INLAND FISHERIES AND WILDLIFE NATURE PARK - ADDENDUM #1

date: May 13, 2024
project: Inland Fisheries and Wildlife Store and Admin Office Project # 3096
prepared by: Ryan Kanteres Simons Architects
Adam Wiles-Rosell Simons Architects
Mikayla Molta Simons Architects

Subject: **Addendum #1** to Bid Documents of April 23, 2024

② ADMIN ENTRY VESTIBULE AT STOREFRONT CORNER
3" = 1'-0"

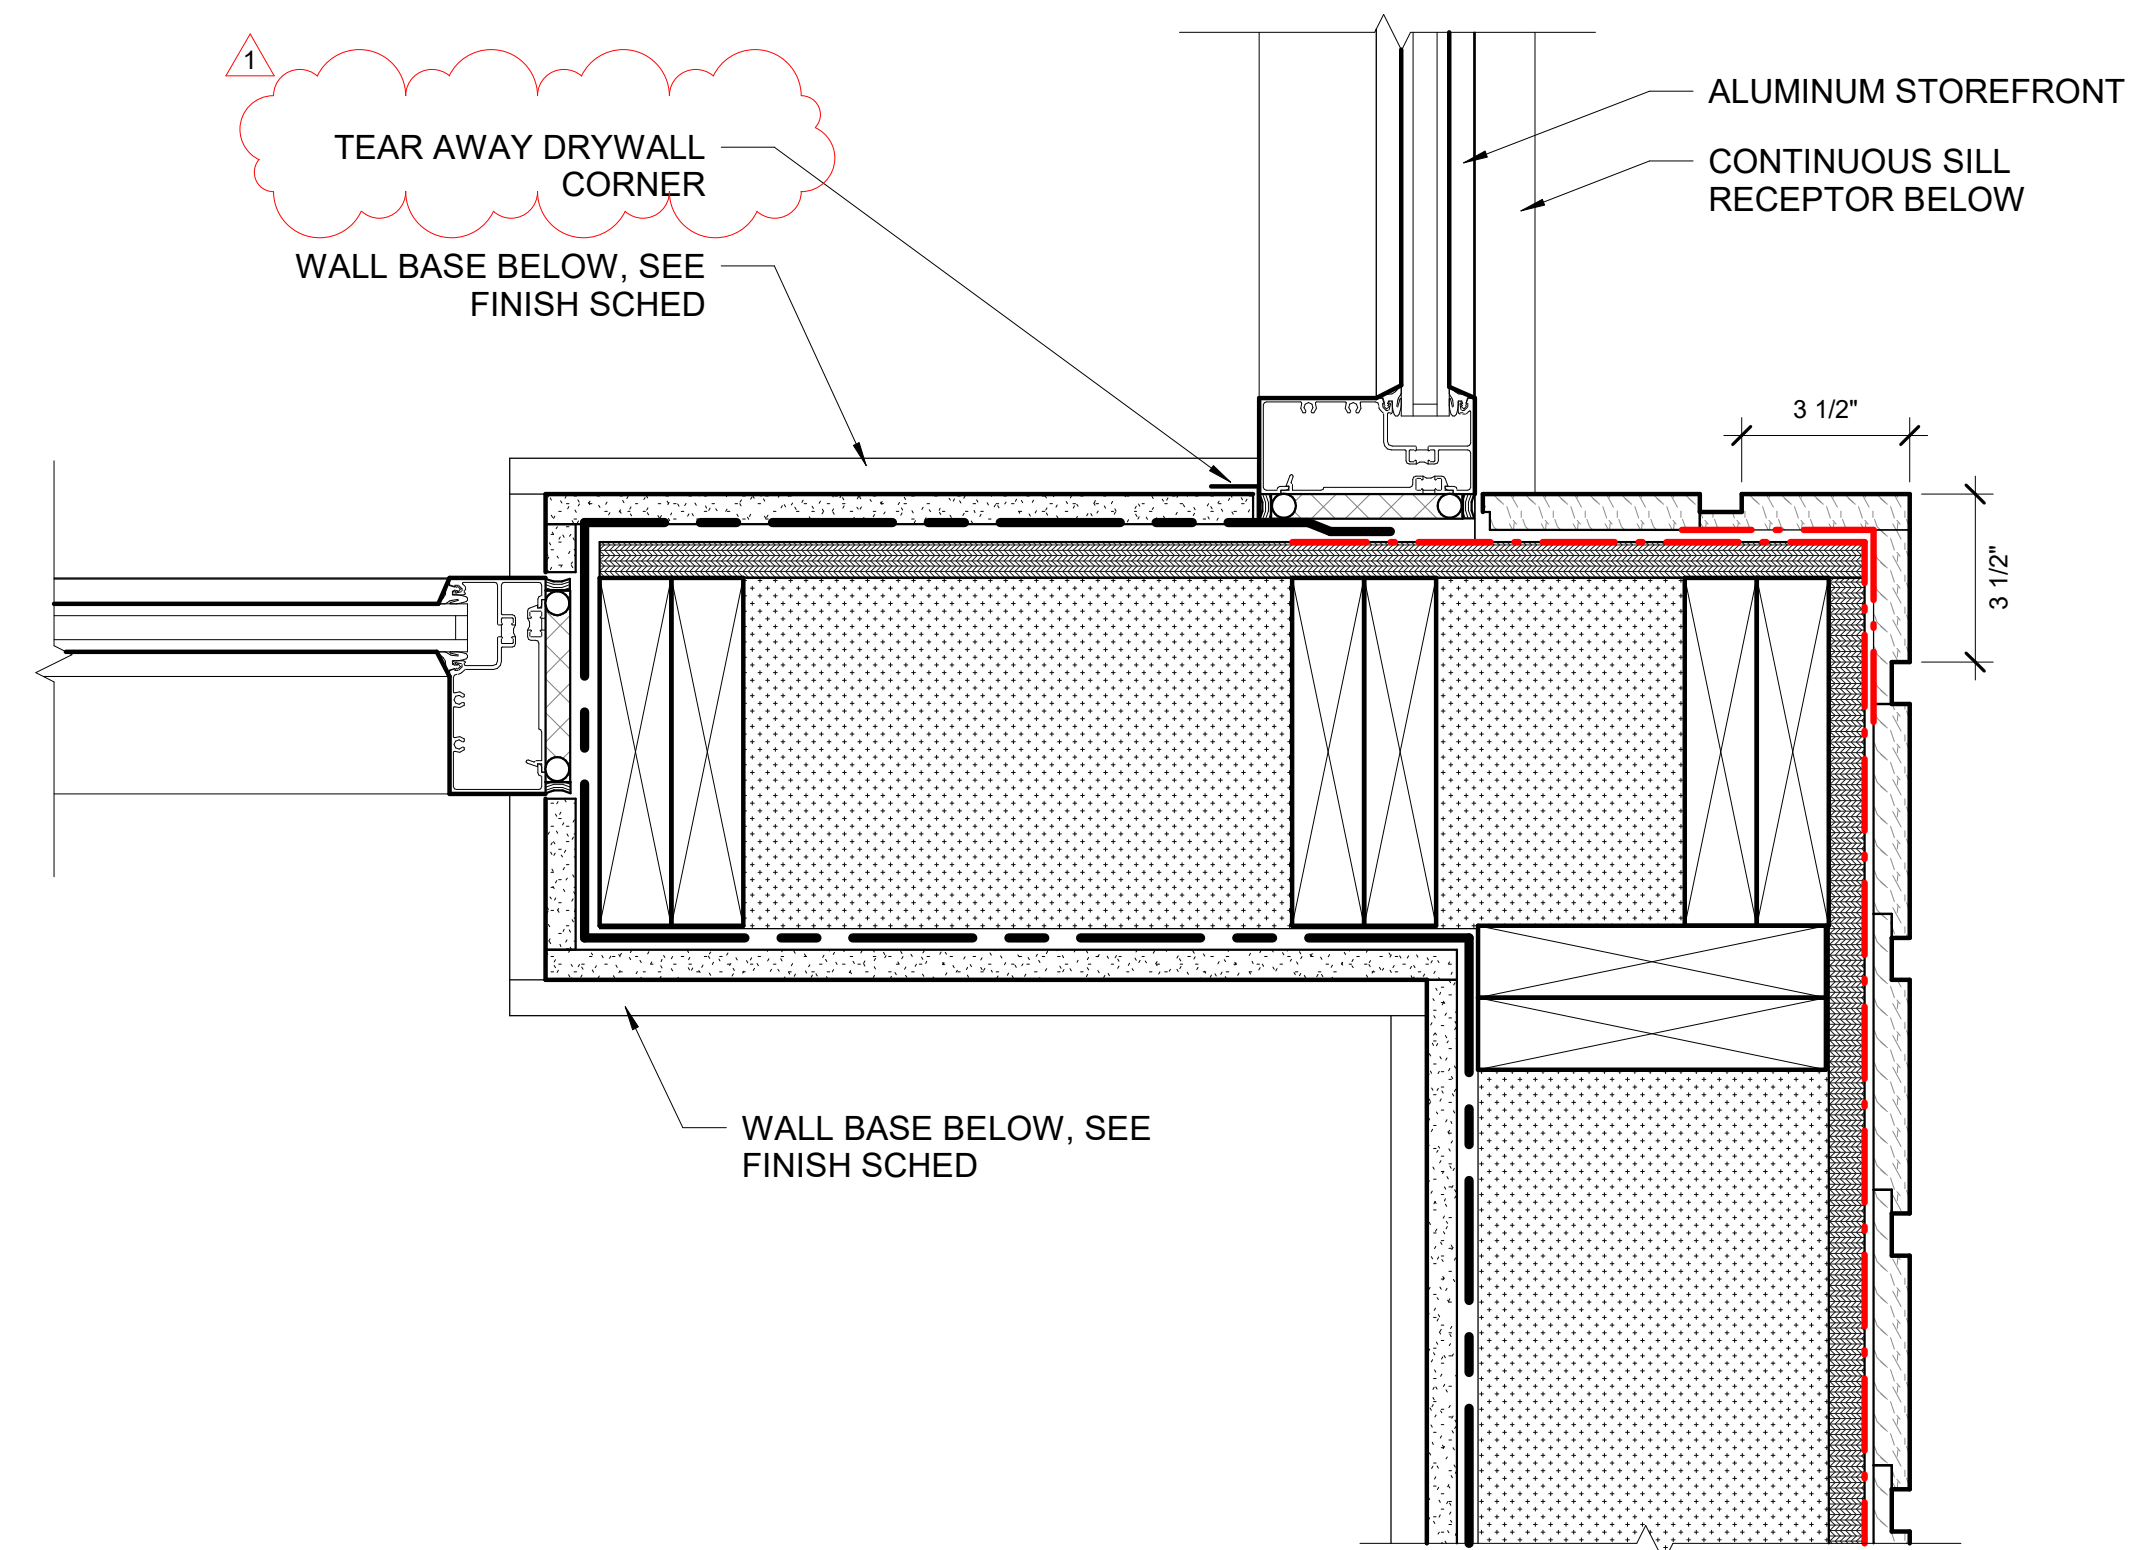
- 1-D17 Sheet A401 Coordinated post locations and sizes with structural drawings. Included 2x material for drywall fastenings and included tear away beads at window intersections. Adjusted door trim due to global 3/4" to 1/2" sheathing adjustment.
